LOT 108 EXPANDED PARKING AND PRACTICE PITCH

ADDENDUM #2

Project Name: Lot 108
Expanded Parking and Practice Pitch

Project Number: 1101-001

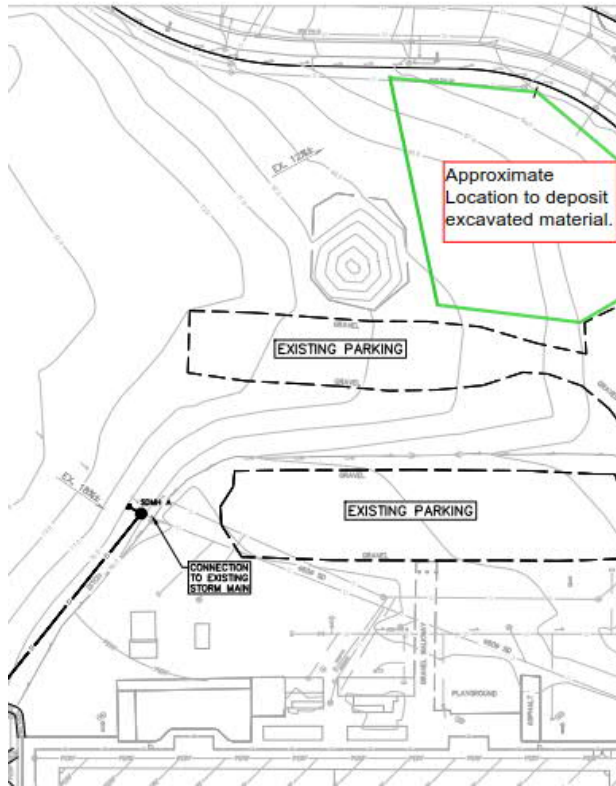
.5 In the pay item descriptions for Common Excavation, it states that removal of material is to be taken to the onsite dump area. Please confirm where onsite the dump area is.

A5: The area will be in the NE corner of the lot, adjacent to an existing pile and existing gravel parking. See the image below.
